ON-SITE SEWAGE DISPOSAL SYSTEM HOWARD COUNTY HEALTH DEPARTMENT BUREAU OF ENVIRONMENTAL HEALTH

SUBDIVISION: CABIN HILL LOT NUMBER: 7-B

ADDRESS: 12925 KENTBURY DRIVE PROPERTY OWNER: US FINANCIAL CAPITAL

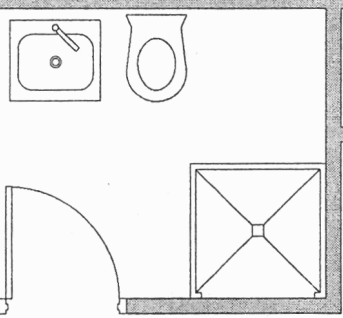
PRE-CONSTRUCTION 1/13/03 Lot not staked, house conn change, back of P.T. to drop 3.5-4' OK. will have 2' in front. Stake lot (SO)

INSTALLATION 1/16/03 - 1st trench & dosing line installed. Had to wiggle around some very lg trees. in 6" off contour at end of 120' trench (SO)

1/16/03 Equipment broke, about 15' of 2nd trench dug. (SO)

1/16/03 - 2nd trench finished, end of trench 8" too deep from going around lg trees. Pump & Alarm test needed (SO)

5/16/03 Pump & Alarm tests OK (SO)

12925 Kentbury Dr
Clarksville, MD 21029
Basement Floor Plan

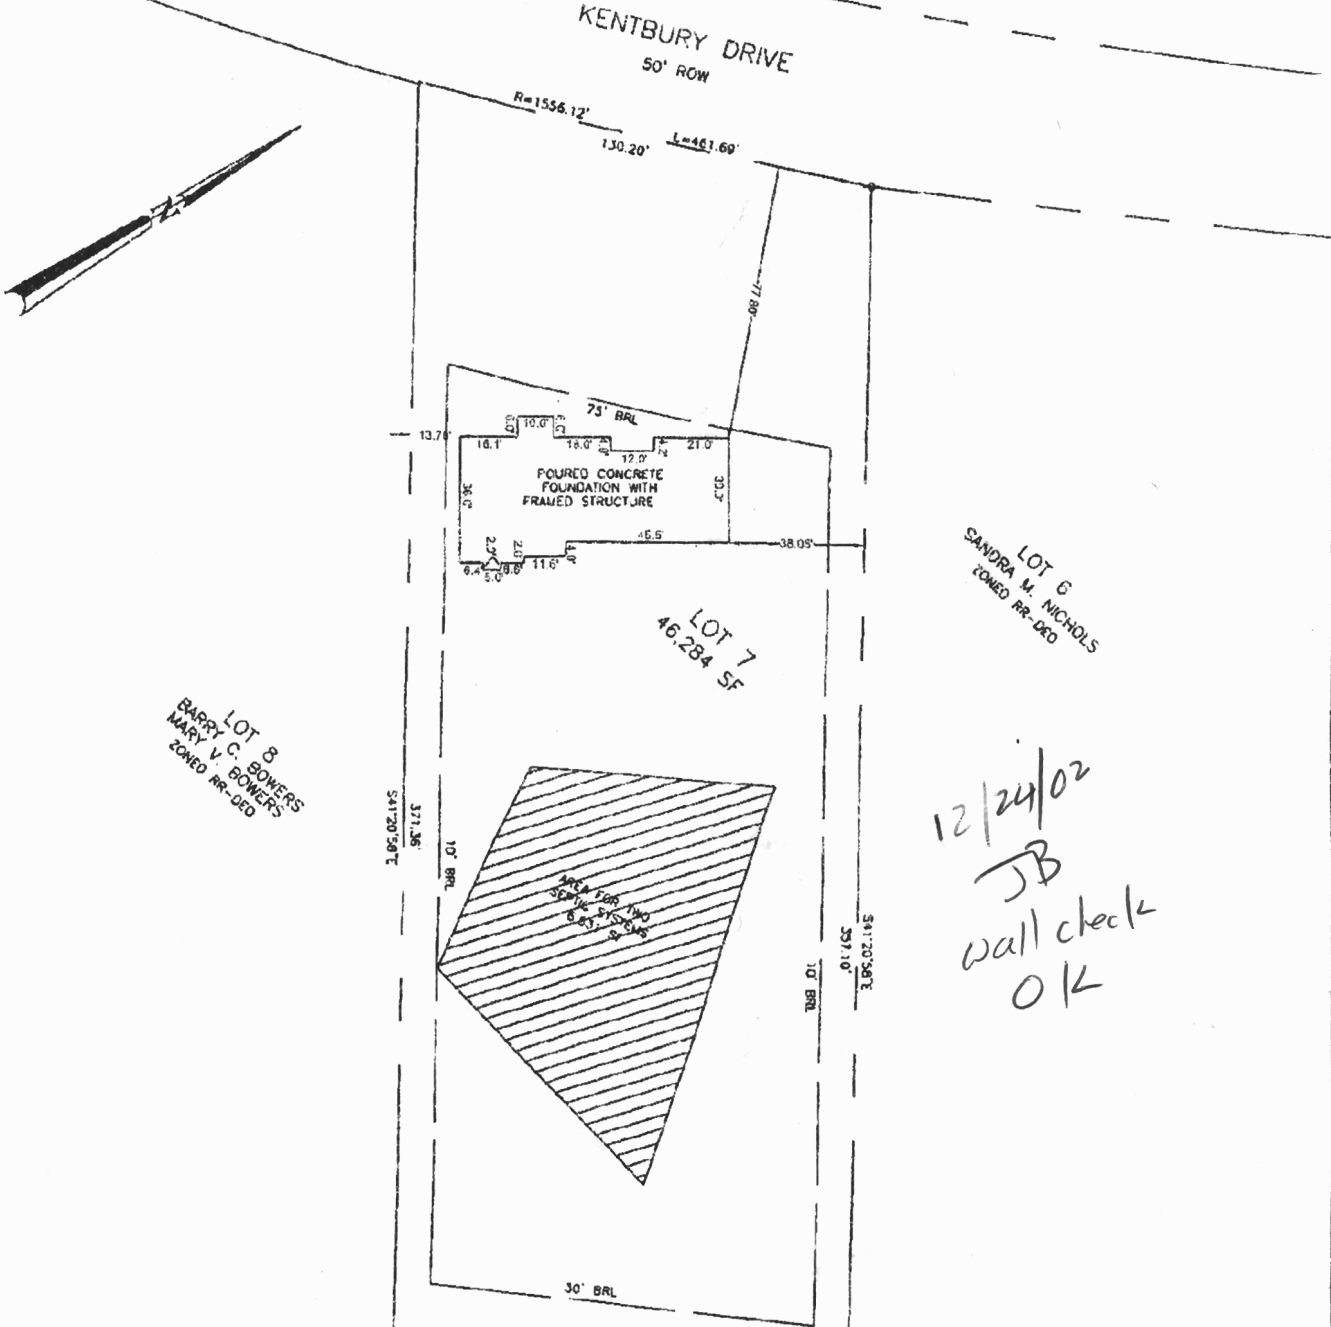
Approved by
no proposal for
additional bedrooms.
